Airworthiness Directives; Bell Helicopter Textron Canada Model 222, 222B, 222U, 230, and 430 Helicopters

ACTION: Notice of proposed rulemaking (NPRM).

Bell Helicopter Textron Canada: Docket No. FAA–2008–0071; Directorate Identifier 2006–SW–27–AD. Supersedes AD 2005–04–09, Amendment 39 13981, Docket No. FAA–2005–20107.

Figure 1

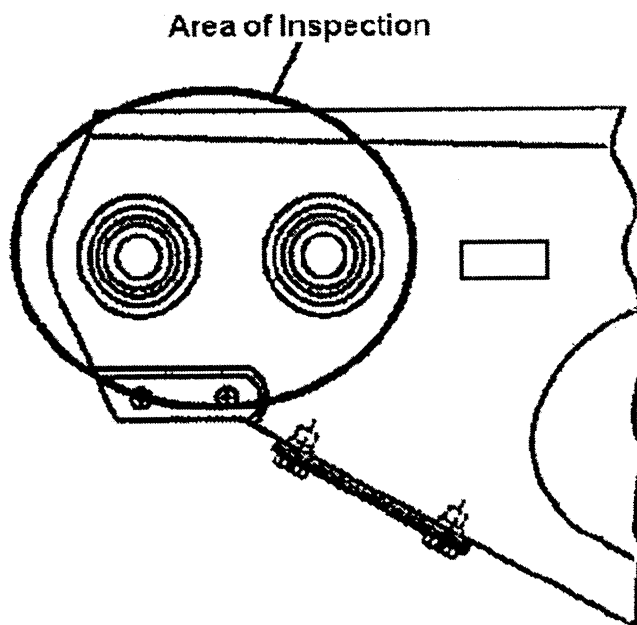
(a) Within 3 hours time-in-service (TIS), unless accomplished previously, and thereafter at intervals not to exceed 3 hours TIS, clean and visually check both sides of each blade for a crack in the paint in the areas shown in Figure 1 of this AD. An owner/operator (pilot), holding at least a private pilot certificate, may perform this visual check and must enter compliance with this paragraph into the helicopter maintenance records by following 14 CFR sections 43.11 and 91.417(a)(2)(v).

(c) Within the next 50 hours TIS, unless accomplished previously, and thereafter at intervals not to exceed 50 hours TIS, clean the blade by wiping down both surfaces of each blade in the inspection area depicted in Figure 1 of this AD using aliphatic naphtha (C-305) or detergent (C-318) or an equivalent. Using a 10X or higher power magnifying glass, visually inspect both sides of the blade in the areas depicted in Figure 1 of this AD.

(d) On or before 90 days after the effective date of this AD, replace any affected serial-numbered blade with an airworthy blade that has a S/N that is not subject to, or has been excepted from, the requirements of this AD. Installing an airworthy blade that is not subject to the requirements of this AD,
